Access Compliance Report

Public Rights-of-Way (Curb Ramps)

Intersection ID: 9217	Main Street: BROWNS_AV	Cross Street: FREEDOM_DR	Location: NW
ADA ID: C0AF6F618555	Ramp Type: Perp	Initial Pass/Fail: Fail	Overall Compliance: No
Severity Score: 13.75			
Codes/Mitigation Info/Possible Solution		Field Measurements/Component Compliance

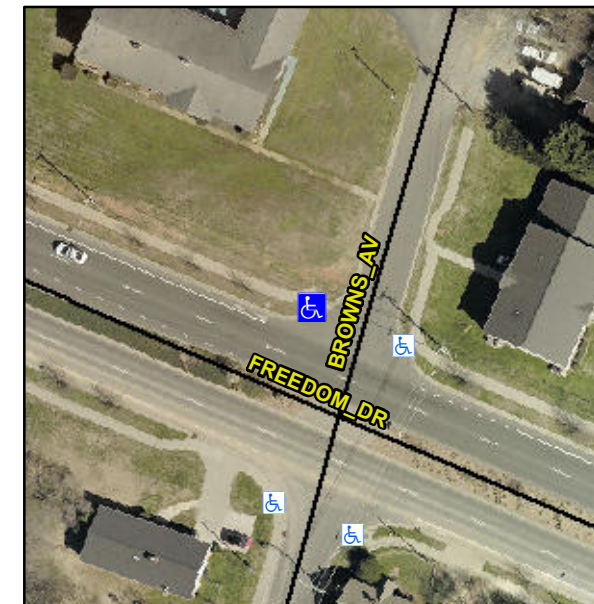
Not Found, R304.2.2, R304.5.3

Compliance	Description	Data	Compliance	Description	Data
N/A	Ramp Length (in)	85.0	No	Ramp Slope (%)	8.4
Yes	Ramp Width (in)	48.0	No	Ramp XSlope (%)	3.1
N/A	Flare Type LT	N/A	N/A	Flare Type RT	N/A
N/A	Flare Slope LT (%)	N/A	N/A	Flare Slope RT (%)	N/A
N/A	Flare Traversable LT?	N/A	N/A	Flare Traversable RT?	N/A
N/A	Landing Length (in)	N/A	N/A	DWS Provided?	N/A
N/A	Landing Width (in)	N/A	N/A	DWS Contrast?	N/A
N/A	Landing Slope (%)	N/A	N/A	DWS Length (in)	N/A
N/A	Landing X Slope (%)	N/A	N/A	DWS Full Width?	N/A
N/A	Landing Curb? (Y/N)	N/A	N/A	DWS Offset (in)	N/A
N/A	Shared Landing?	N/A			
N/A	Gutter Ponding?	N/A	N/A	Gutter Slope (%)	N/A
N/A	Gutter Lip Ht (in)	N/A	N/A	Gutter X Slope (%)	N/A
N/A	Painted X Walk1?	No	N/A	Painted X Walk2?	N/A
	X Walk 1 Direction	To SE		X Walk 2 Direction	N/A
N/A	X Walk 1 Width (in)	N/A	N/A	X Walk 2 Width (in)	N/A
	X Walk 1 Slope (%)	2.8		X Walk 2 Slope (%)	N/A
	X Walk 1 X Slope (%)	0.9		X Walk 2 X Slope (%)	N/A

Remove & Replace Entire Ramp.
